ADDENDUM #1
ISSUED: JUNE 24, 2024

SECTION 00 91 14: SUPPLEMENTAL SHEETS

ECPPS Warehouse Freezer Replacement
Elizabeth City, North Carolina

1 AD101 ENLARGED SITE/DEMOLITION PLAN
SCALE: 1/16" = 1'-0"

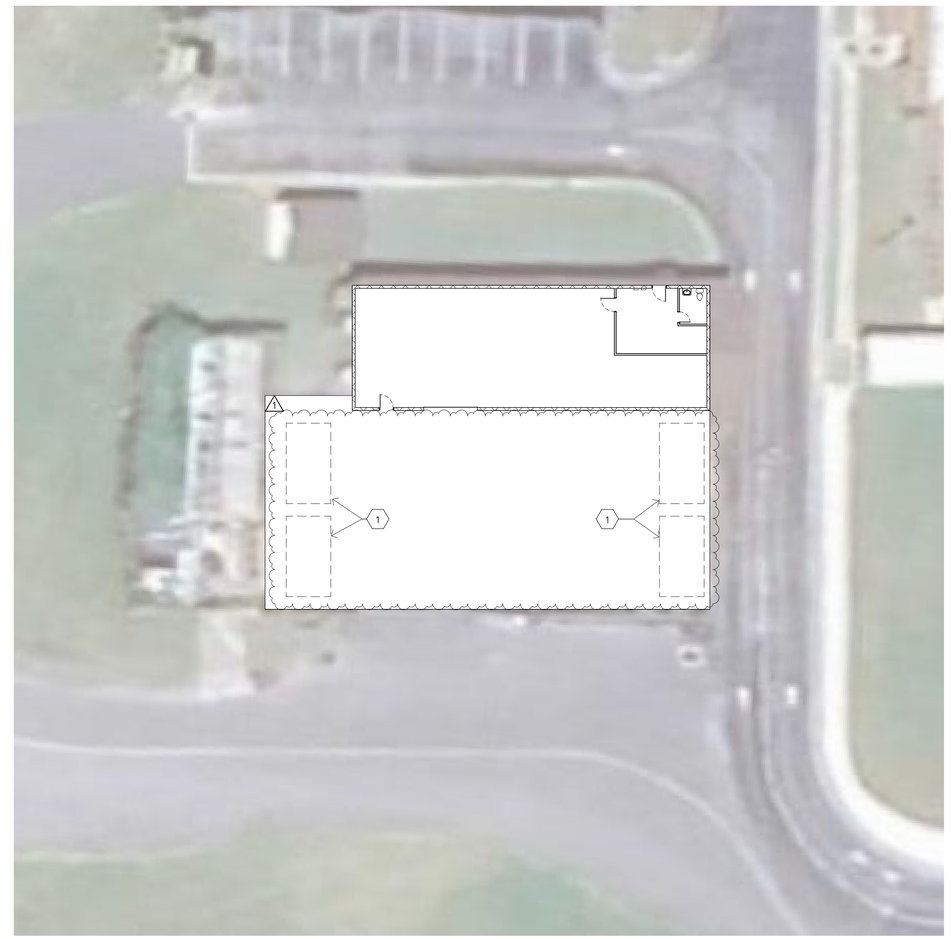
A. SHEET AD101 – ENLARGED SITE AND DEMOLITION PLAN – Delete this Sheet in its entirety and replace with SHEET AD101 – ENLARGED SITE AND DEMOLITION PLAN – Addendum #1 dated May 8, 2024.

2 MTS/GENERATOR DOCKING STATION DETAIL

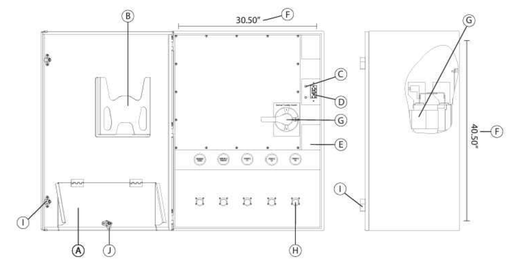
◇1 ~~PROVIDE WITH INTERGRAL GENERATOR TAP BOX~~ WITH CAM–LOK CONNECTORS (2 WIRE PLUS NEUTRAL AND GROUND) FOR CONNECTION TO A TEMPORARY GENERATOR. POWERTRON MTS SERIES OR APPROVED EQUAL. △1

A	Trapped Cable Door Patented #US D771,580 S UL Verified Mark #: A061453
B	Owner's Manual Holder
C	Remote Start/Stop Terminals
~~D~~	~~GFCI 20 Amp Receptacle~~
~~E~~	~~Cover plate shall not be removed when installing Powertron® Phase Rotation Monitor~~
F	Mounting Hole Pattern – (4X) 0.50" dia.
G	Manual Transfer Switch: connection point mechanical lug 2 AWG to 600 KCMIL per phase
H	Series 16, 400 Amp, 600 VAC, Single Pole Cam-Lock Receptacle
I	Key Lock Handle
J	Quarter Turn Twist Lock Handle (non-locking)
